**Connecticut River Conservancy Comments on Great River Hydro, LLC Study Reports filed by  
February 9, 2018; Request for Study Modification to Require Compliance with the RSP.**

CRC again hired consulting engineering firm Princeton Hydro (<http://www.princetonhydro.com/>) to conduct a peer review of the ILP Study 2 and Study 3 Riverbank Transect and Riverbank Erosion Study Supplement to Final Study Report ("Supplement") which was submitted to the Commission by Great River Hydro on November 15, 2017. Princeton Hydro's review is attached to this comment letter. We include some of their major conclusions below as part of our formal comments.

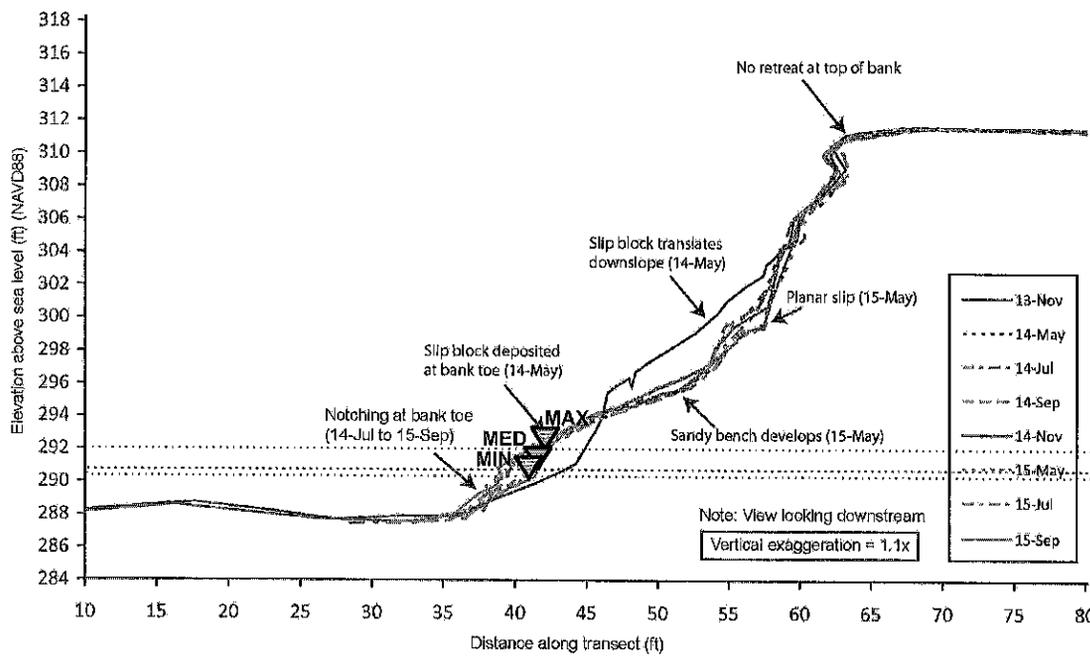
7. The methodology as described of the shear stress and velocity analysis conforms to generally accepted scientific practice. Literature references for published critical velocities and critical shear stresses are valid and applicable.

8. A preliminary review of the HEC-RAS model files yielded the following observations:
  - a. Model domains appeared to cover substantial river length and over-bank areas.

- b. Of the 2-D geometries examined, it could not be confirmed if breaklines had been used to more accurately represent breaks in slope like at the top of bank or at the bottom of bank. River bathymetry appeared to be very uniform, potentially lacking detail. Topography on the floodplain appeared to be much more varied and detailed.

Selected river stages at 02-B03 (Jarvis Island Site).

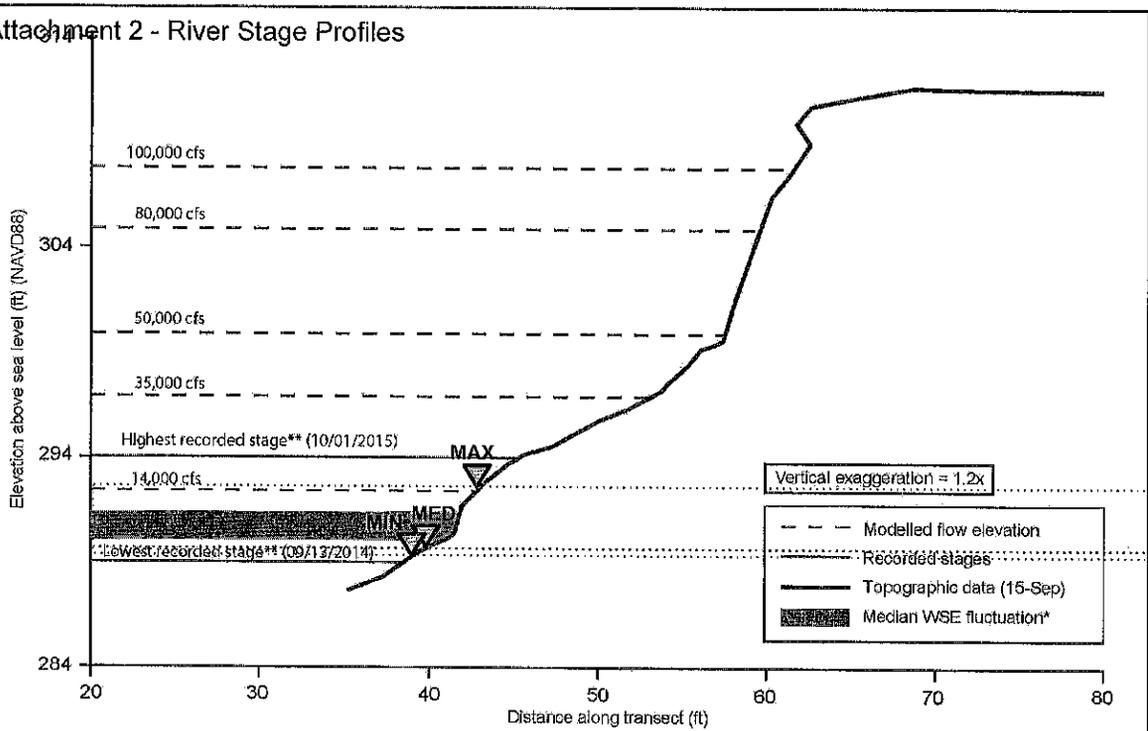
\*Note: Median WSE fluctuation at site equals 4.5 feet under no-spill conditions  
 \*\*Note: Flow stage recorded at site from 06/2014 - 11/2014 and 07/2015 - 11/2015

Selected river stages at 02-V06 (LaCroix Site).

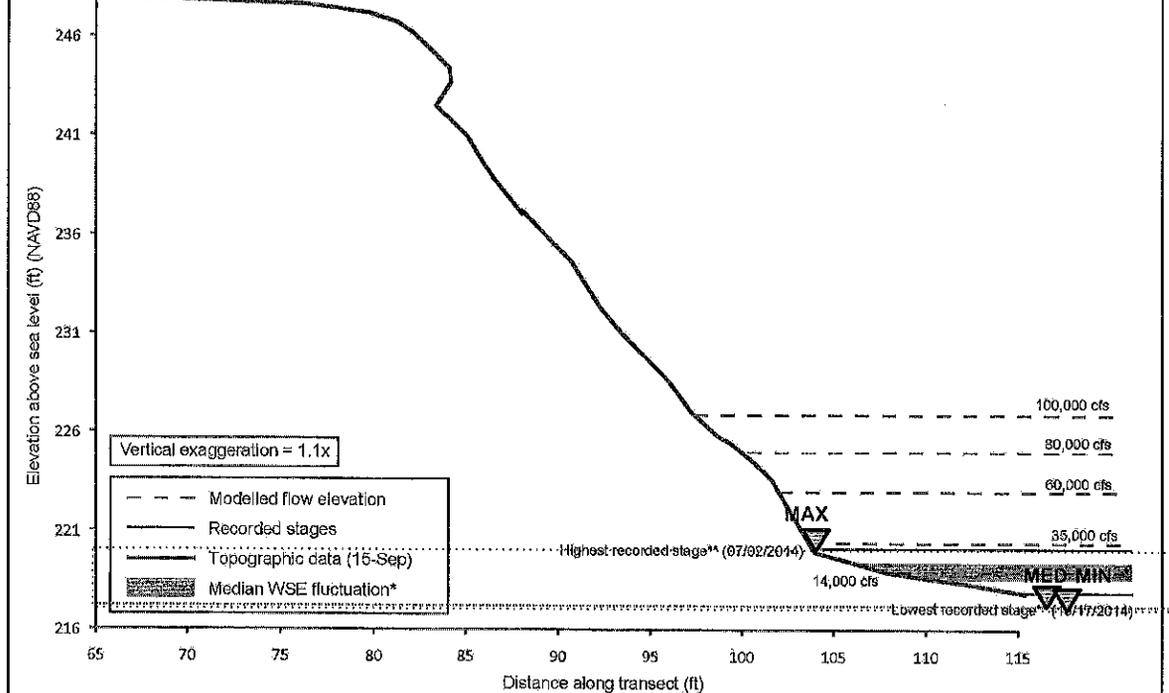
\*Note: Median WSE fluctuation at site equals 0.9 feet under no-spill conditions  
 \*\*Note: Flow stage recorded at site from 08/2014 - 11/2014 and 07/2015 - 11/2015

Selected river stages at 02-W10 (Vaughn Site).

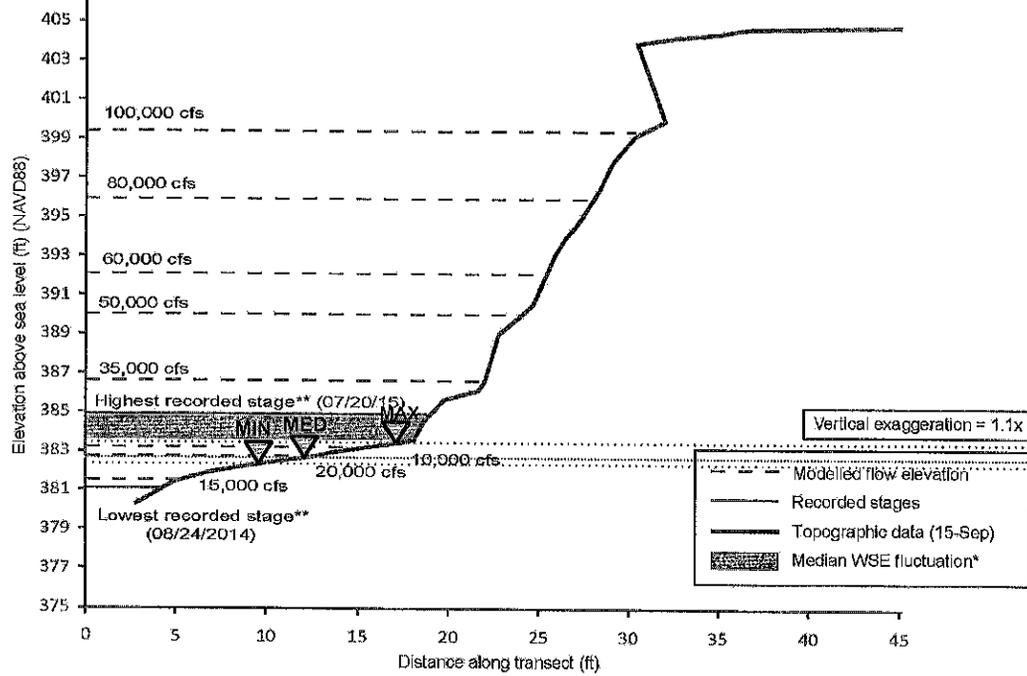
\*Note: Median WSE fluctuation at site equals 1.11 feet under no-spill conditions
